APPLICATION NO.	FILING DATE	FIRST NAMED INVENTOR	ATTORNEY DOCKET NO.	CONFIRMATION NO.
09/779,478	02/09/2001	Toru Yamaguchi	018842.1162	9443
24735 7:	24735 7590 10/19/2004		EXAMINER	
BAKER BOTTS LLP			LEO, LEONARD R	
C/O INTELLE	CTUAL PROPERTY DEF	PARTMENT		
THE WARNER, SUITE 1300			ART UNIT	PAPER NUMBER
1299 PENNSYLVANIA AVE, NW			3753	
WASHINGTO	N, DC 20004-2400		DATE MAILED: 10/19/2004	4

Application No.	Applicant(s)			
		09/779,478	YAMAGUCHI ET AL.			
	Office Action Summary	Examiner	Art Unit			
		Leonard R. Leo	3753			
Period fo	The MAILING DATE of this communication apor Reply	opears on the cover sheet	with the correspondence address			
THE I - Externance - If the - If NO - Failu - Any r	ORTENED STATUTORY PERIOD FOR REP MAILING DATE OF THIS COMMUNICATION nsions of time may be available under the provisions of 37 CFR 1 SIX (6) MONTHS from the mailing date of this communication. period for reply specified above is less than thirty (30) days, a re- period for reply is specified above, the maximum statutory perior re to reply within the set or extended period for reply will, by statu- eply received by the Office later than three months after the mailing ad patent term adjustment. S

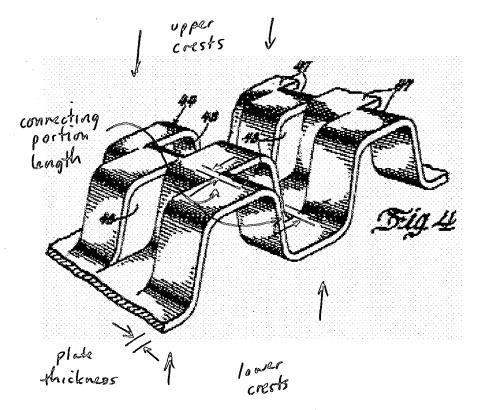
The rejection in view of Gerstung is maintained. The Examiner disagrees with applicants' interpretation of Gerstung (page 2, column 1, lines 60-66) below.

With respect to the Figure 4 of Gerstung, connecting portions of an outer surface of an upper flat crest and connecting portions of an inner surface of a lower flat crest are disclosed. The connecting portion on the inner surface of the *lower flat crest* is believed to be the same as the connecting portion on the inner surface of the *upper flat crest*. The structure of where the "flat crests are not separated" is where the adjoining elements 47 are uncut and not severed as shown in red below. As permissibly gleaned from the drawing, the length (T) of the connecting portion of Gerstung is less than plate thickness (t).

As per MPEP 2125, proportions are permissibly gleaned from the drawings. Figure 4 of Gerstung clearly conveys to one of ordinary skill in the art that the connecting portion of the inner surface and the connecting portion of the outer surface have lengths less than the thickness of the plate. Furthermore, the Examiner is not relying upon the proportions to determine a specific dimension. The drawing discloses a proportional relationship between the connecting portions and the plate thickness. Thus, the scale of the drawing is irrelevant.
